**NOTICE OF A SPECIAL CABINET MEETING:**

**DATE: THURSDAY 17 SEPTEMBER 2009**

Airtrack Transport and Works Act Submission [DCX]

## **AIRTRACK TRANSPORT AND WORKS ACT SUBMISSION**

Figure A2.1.3 Proposed Land Use Changes

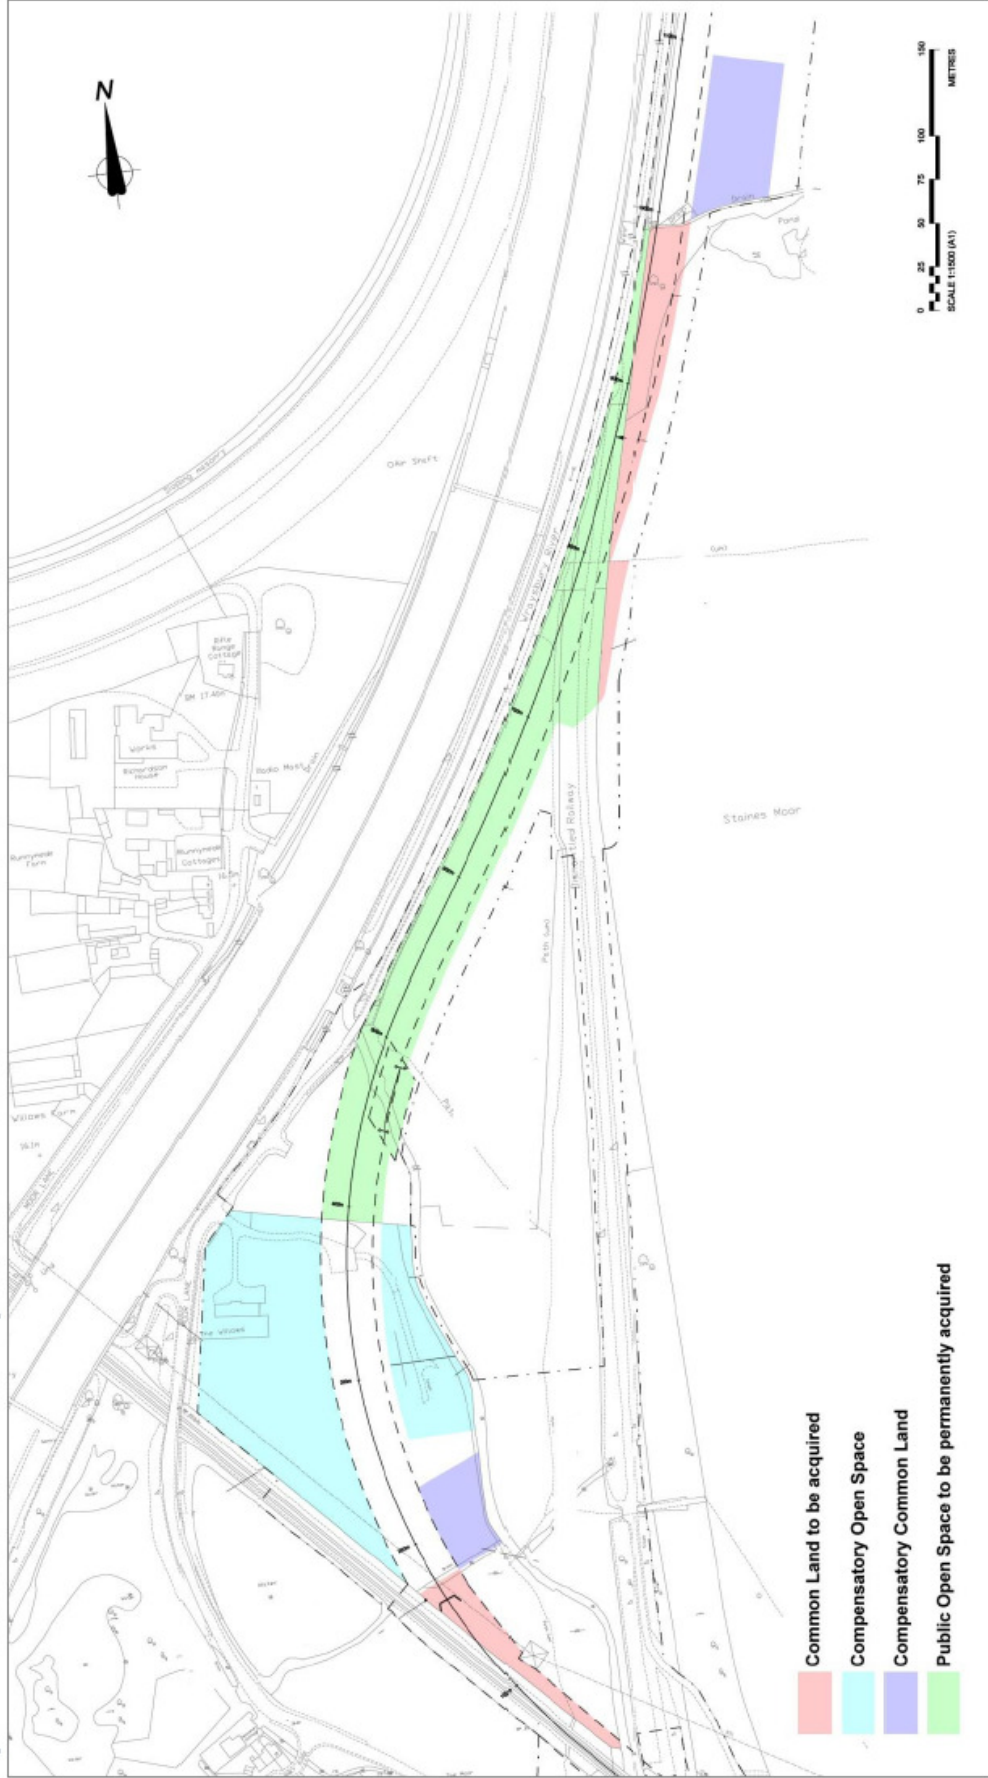
- 7.29 The land identified in the deposited plans and sections, sheet no.4, area 75 is inappropriate land for ecological mitigation. Based on the preliminary results of Spelthorne's independent vegetation surveys, this area is one of the richest in the field to the west of the disused railway embankment, and there are other areas in that field that are of less botanical interest and thus more suitable to disturb in order to carry out mitigation. There is insufficient data in the Airtrack Phase 2 survey included in the Environmental Statement to support HAL's conclusions.

- 15. HAL is not seeking to acquire area E4 or Butts Pond which the SMMS identifies as a part of the strategy to mitigate for habitat impacts.**
- 16. Insufficient evidence has been produced to demonstrate that the proposed translocation of plant species can be successfully achieved and adequate land area of appropriate quality has the ability to reproduce the ecological functions and conditions of these habitats that have been lost or damaged.**

**Figure 13.5 Location of Noise Barriers**

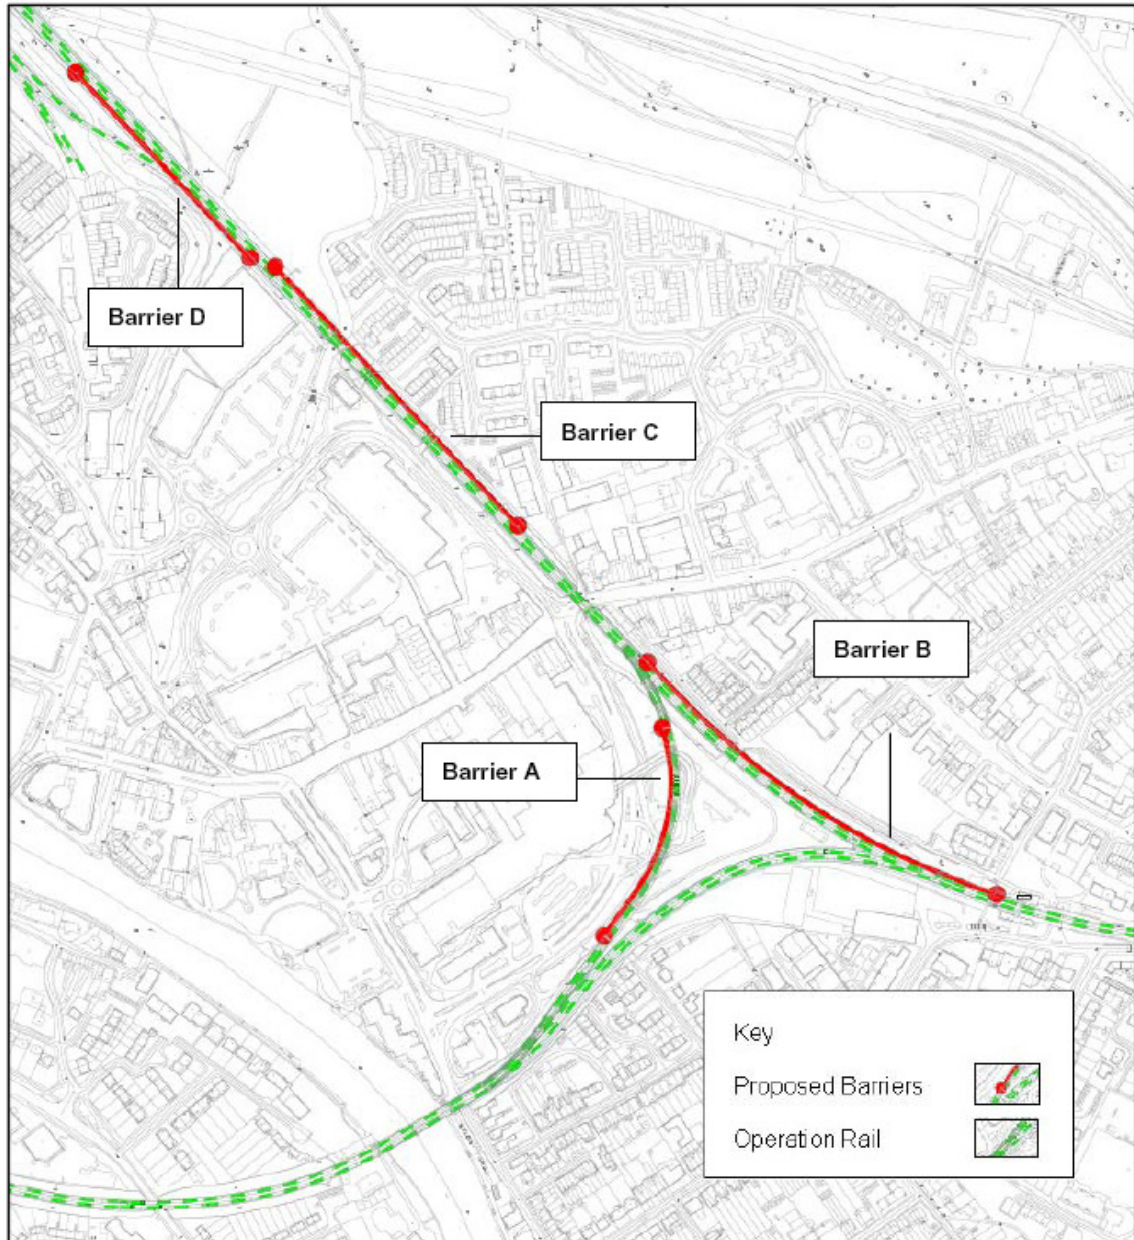
12. Unless otherwise approved in writing by the local planning authority, noise barriers or other mitigation measures shall be provided from the station westwards on the whole length of the new retaining wall alongside Station Path shown in volume 3 of the Heathrow Airtrack Environmental Statement (Route Alignment Plan and Profile Sheet 1) so that the residual adverse noise effects to sensitive receptors is no worse than that identified in Chapter 13 and Appendix 13.1 of the Heathrow Airtrack Environmental Statement. These measures shall be provided before the Airtrack or Heathrow Express services to Staines become operational and shall thereafter be maintained.
